Access Compliance Report

Public Rights-of-Way

(Curb Ramps)

Intersection ID: 52288	Main Street: STEELE_CREEK_RD	Cross Street: DIXIE_RIVER_RD	Location: W
ADA ID: EE5BCE9F5ED8	Ramp Type: Para	Initial Pass/Fail: Pass	Overall Compliance: No
		Severity Score: 0

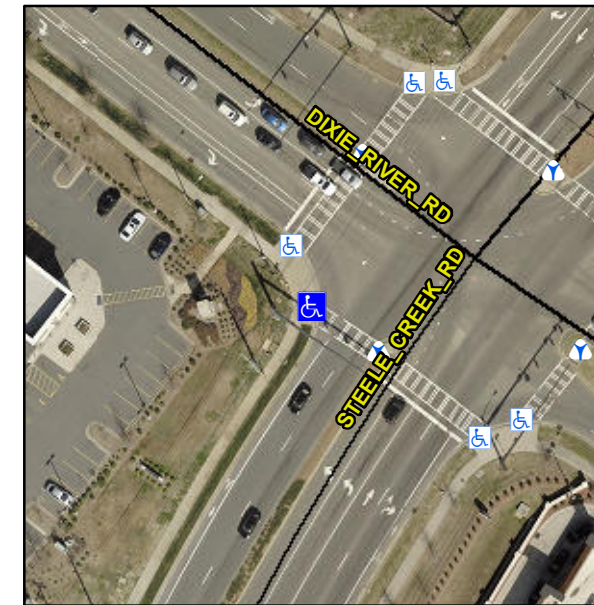
R304.2.1, R304.5.3

Remove & Replace Landing.
